# Access Compliance Report

## Public Rights-of-Way

Intersection ID: 14272	Main Street: BROOKHILL_RD	Cross Street: VILLAGE_CT	Location: NW
ADA ID: 80DB384D4716	Ramp Type: PerpDiag	Initial Pass/Fail: Fail	Overall Compliance: No
Severity Score: 13.75			
Codes/Mitigation Info/Possible Solution		Field Measurements/Component Compliance

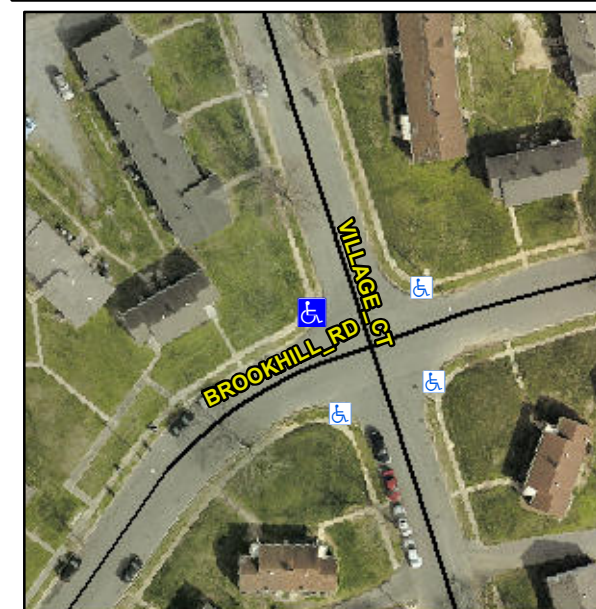
**Not Found, R304.2.2, R304.5.3**

Compliance	Description	Data	Compliance	Description	Data
N/A	Ramp Length (in)	92.0	No	Ramp Slope (%)	11.9
Yes	Ramp Width (in)	48.0	No	Ramp XSlope (%)	4.3
N/A	Flare Type LT	N/A	N/A	Flare Type RT	N/A
N/A	Flare Slope LT (%)	N/A	N/A	Flare Slope RT (%)	N/A
N/A	Flare Traversable LT?	N/A	N/A	Flare Traversable RT?	N/A
N/A	Landing Length (in)	N/A	N/A	DWS Provided?	N/A
N/A	Landing Width (in)	N/A	N/A	DWS Contrast?	N/A
N/A	Landing Slope (%)	N/A	N/A	DWS Length (in)	N/A
N/A	Landing X Slope (%)	N/A	N/A	DWS Full Width?	N/A
N/A	Landing Curb? (Y/N)	N/A	N/A	DWS Offset (in)	N/A
N/A	Shared Landing?	N/A			
N/A	Gutter Ponding?	N/A	N/A	Gutter Slope (%)	N/A
N/A	Gutter Lip Ht (in)	N/A	N/A	Gutter X Slope (%)	N/A
N/A	Painted X Walk1?	No	N/A	Painted X Walk2?	No
	X Walk 1 Direction	To S		X Walk 2 Direction	To E
N/A	X Walk 1 Width (in)	N/A	N/A	X Walk 2 Width (in)	N/A
	X Walk 1 Slope (%)	7.5		X Walk 2 Slope (%)	0.1
	X Walk 1 X Slope (%)	0.6		X Walk 2 X Slope (%)	7.0

**Remove & Replace Curb Ramp With Two New Directional Ramps or Equivalent.**
